ADDENDUM NUMBER 1

BOARD OF WATER AND SEWER COMMISSIONERS OF THE CITY OF MOBILE, ALABAMA MAWSS KIOSKS

GMC PROJECT NO. AMOB24029

AD1-1 CLARIFICATIONS / RFI RESPONSES / ADDITIONS / ETC.:

5 SIGNAGE ABOVE DRIVE THRU ENTRANCE SCALE: 1/2" = 1'-0"

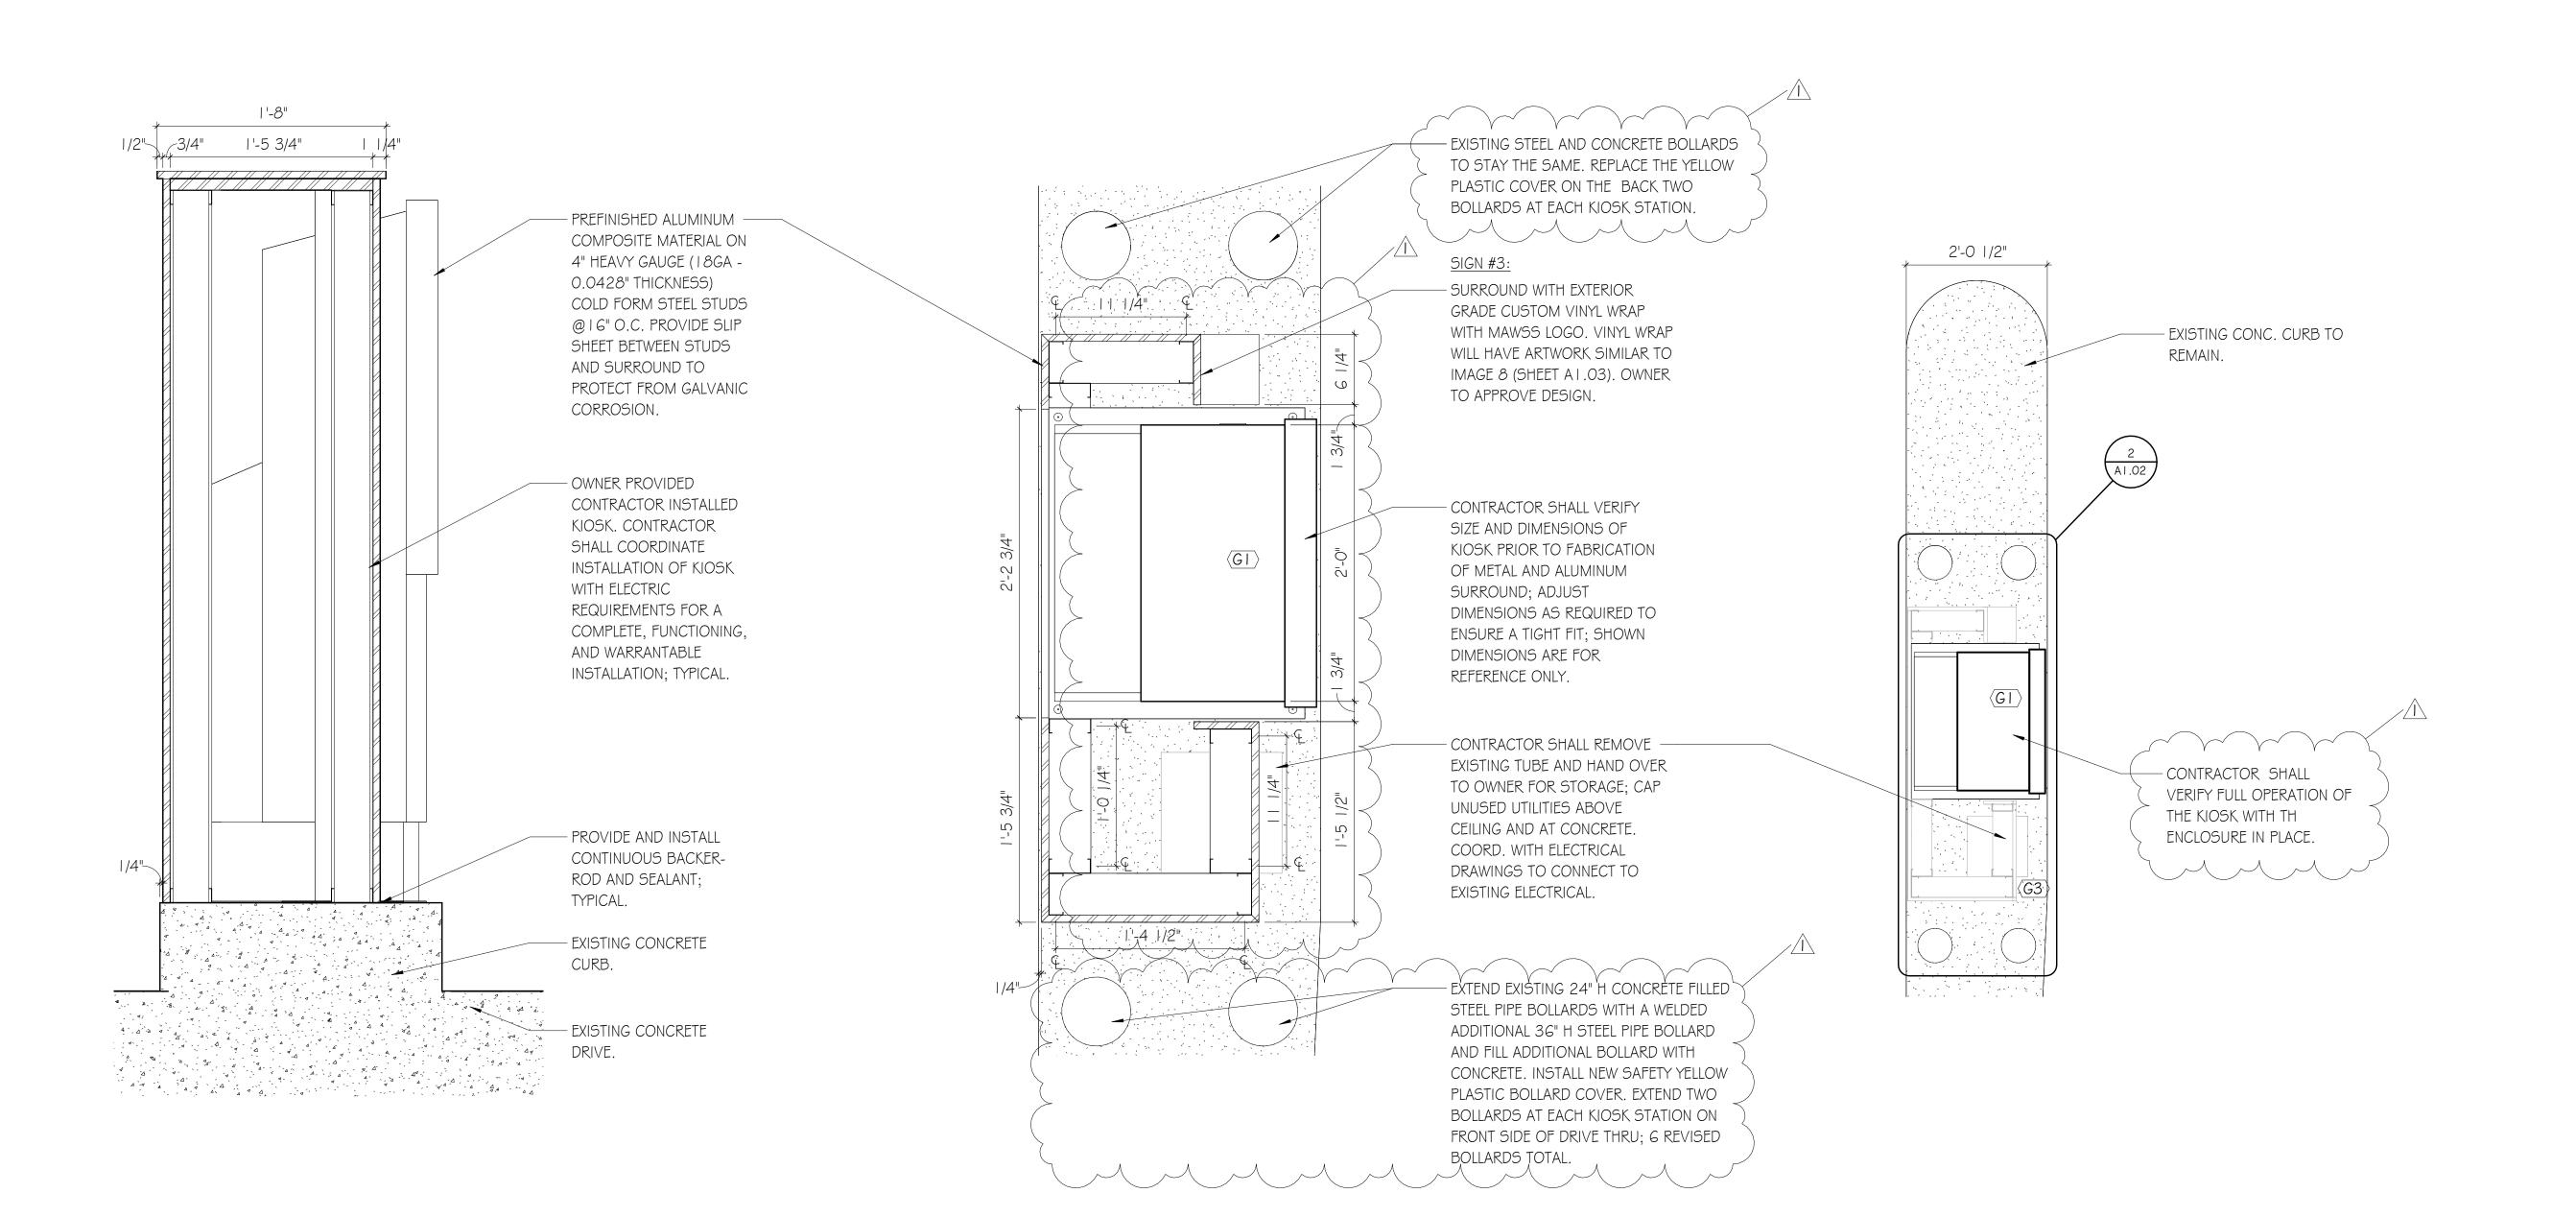
- I. Wrico Signs has MAWSS logo information and has done the MAWSS signage in the past.
- J. Remove existing ATM in first lane of drive-thru that is in building wall. Leave ATM in building. Cap wall opening with steel plate and seal edges. Paint steel plate in tan color to match masonry.
- K. Pressure wash building, concrete drive-thru surface and curbs, and concrete sidewalks and curbs.
- L. Replace existing sheet A1.02 with new sheet attached A1.02 dated 11/18/2024 clouded with Rev 1.

__4'-7 7/8"<u>__</u> <u>4'-7 7/8"</u> - INSTALL 3M WINDOW PERF FILM ON GLASS WITH MAWSS LOGO. DESIGN OF APPLIED VINYL WILL BE SIMILAR TO IMAGE 7 (SHEET WINDOW DETAIL A I .03). OWNER TO APPROVE SCALE: 3/4" = 1'-0" DESIGN.

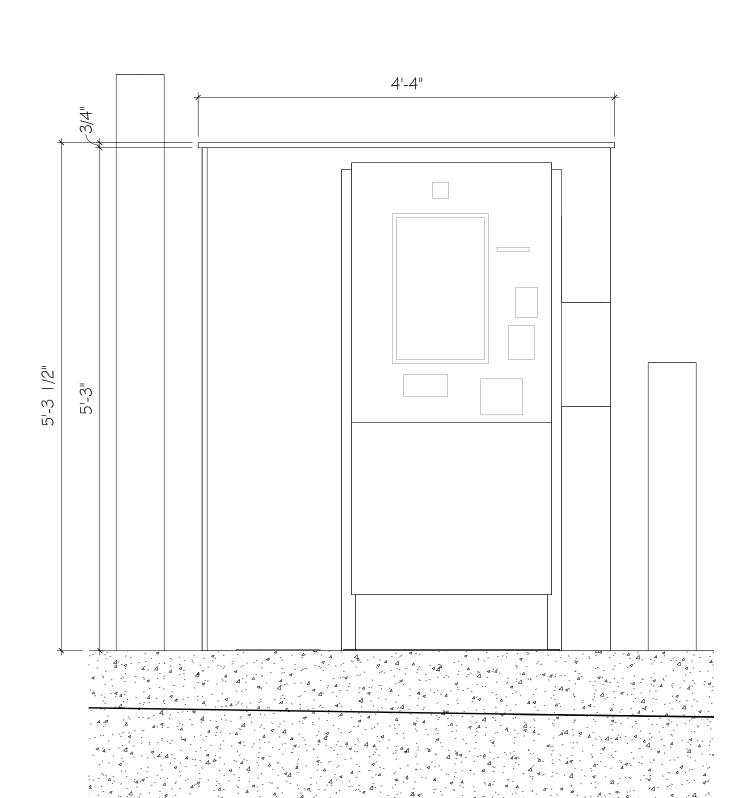
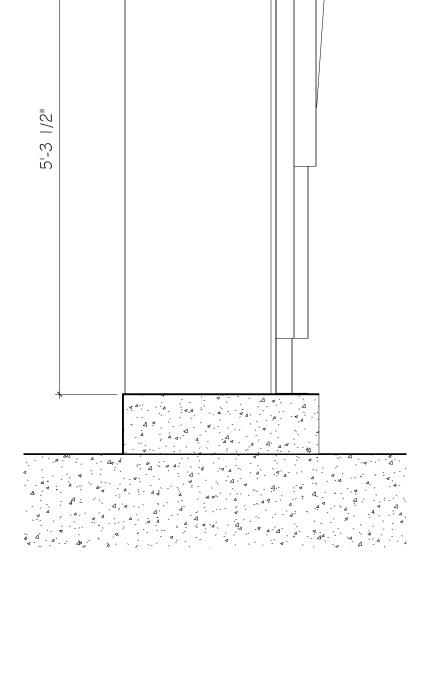
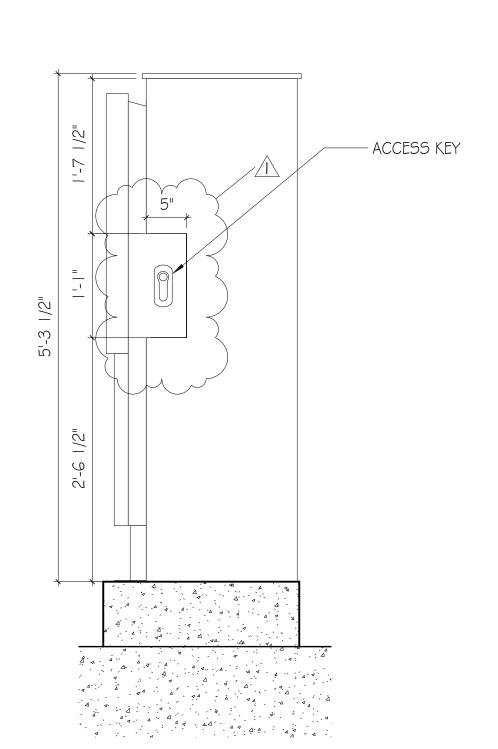
- A. Addendum Acknowledgment Response
- B. Pre-Bid Meeting Agenda/ Meeting Minutes
- C. Pre-Bid Meeting Sign-in sheet
- D. Sheet A1.02 dated 11/11/2024 clouded with Rev 1.
- E. Sheet A1.03 dated 11/11/2024 clouded with Rev 1.
